Office Action Summary

09/761,375

WILLIAMS, TERRY N.

DETAILED ACTION

FIG. 40

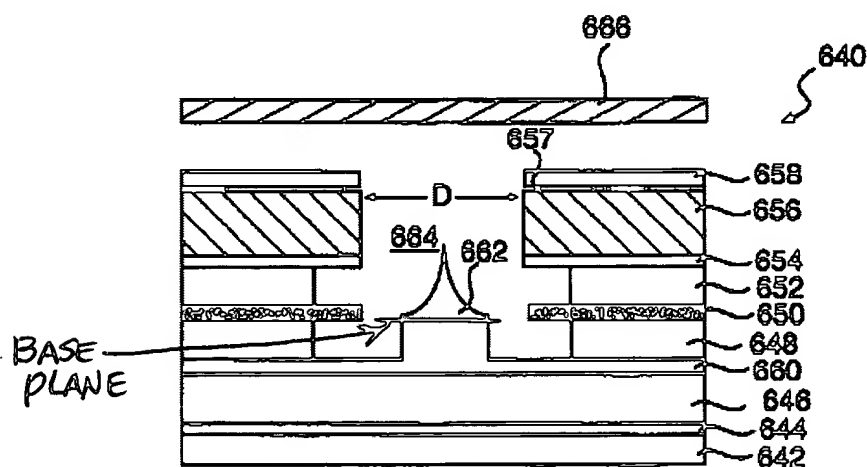
8. With respect to claims 9, 12, 15, and 20, Jones et al. disclose a field emission device comprising a substrate (Fig. 40, 642 & 644); a cathode conductive layer (646) disposed over the substrate; and a monolithic emitter tip (662) integral with and etched entirely from an emitter layer (660) disposed over the cathode conductive layer and having a base plane adjacent to the emitter layer, an apex, and a continuously concave exterior surface extending from the base plane to the apex. Jones et al. also disclose: the exterior surface having a substantially paraboloid vertical profile that extends from the base plane to the apex; and the exterior surface having an ovoid profile that extends from the base plane to the apex. Jones et al. also disclose the emitter tip and the single emitter layer are formed of a single material (column 24, lines 62-65). In Figure 40, Jones et al. also disclose a conductive gate structure (656 & 658) disposed over the

cathode conductive layer (646), an array of apertures (664) formed through the conductive gate structure, each of the emitter tips (662) being exposed through one of the apertures; and an anode panel (666) for emitting light in response to electrons emitted from the array of emitter tips.

9. With respect to claim 18, Jones et al. disclose a field emission device comprising an emitter tip (662) formed from an emitter layer (660), the emitter tip having a height and including a base plane and an apex, wherein the emitter tip is generally conical and has a substantially rectilinear profile between the base plane and the apex, and wherein the emitter tip and the single emitter layer are formed of a single material (column 24, lines 62-65).

10. With respect to claims 10, 13, and 16, Jones et al. disclose a conductive gate structure (Fig. 40, 656 & 658) disposed over the cathode conductive layer (646); an aperture (664) through the conductive gate structure, the emitter tip (662) being

exposed within the aperture, and an anode panel (666) positioned over the conductive gate structure and the emitter tip.

13. With respect to claims 11, 14, and 17, Jones et al. disclose an anode conductive layer (Fig. 40, 666), and a phospholuminescent panel for emitting light upon being excited by electrons (column 10, lines 33-39). Jones et al. do not disclose a transparent panel. However, it would have been obvious to one of ordinary skill in the art to modify the Jones et al. invention and have a transparent panel to provide image output capability of the display device.

However, Jones et al. do disclose all of the above elements. Specifically, Jones et al. disclose “an emitter tip integral with and etched entirely from an emitter layer...and a continuously concave exterior surface extending from the base plane to the apex.” Jones et al., in column 24, lines 62-65, state, “In the embodiment shown in FIG. 40, the emitter element 662 may be etchingly formed to retain a layer 660 of the current limiting emitter material integral with the emitter element 662 as shown.” Applicant relies on the embodiment shown in Fig. 39, which shows “a layered contaminated emitter”; however, the embodiment shown in Fig. 39 is a different embodiment than that shown in Fig. 40, as evidenced by the statement (column 24, lines 7-9), “FIG. 40 is a schematic representation of a tunneling field emitter structure 640 according to another embodiment of the invention.” The embodiment shown in Fig. 40, as discussed above, clearly meets the limitation of “an emitter tip integral with and etched entirely from an emitter layer...and a continuously concave exterior surface extending from the base plane to the apex.” With this being the case, then the limitations of “a monolithic emitter tip...said exterior surface having a substantially paraboloid vertical profile that extends from the base plane to the apex.”; “said exterior surface having an ovoid profile that extends from the base plane to the apex...wherein the emitter tip and the single emitter layer are formed of a single material.”; and “wherein the emitter tip is generally conical
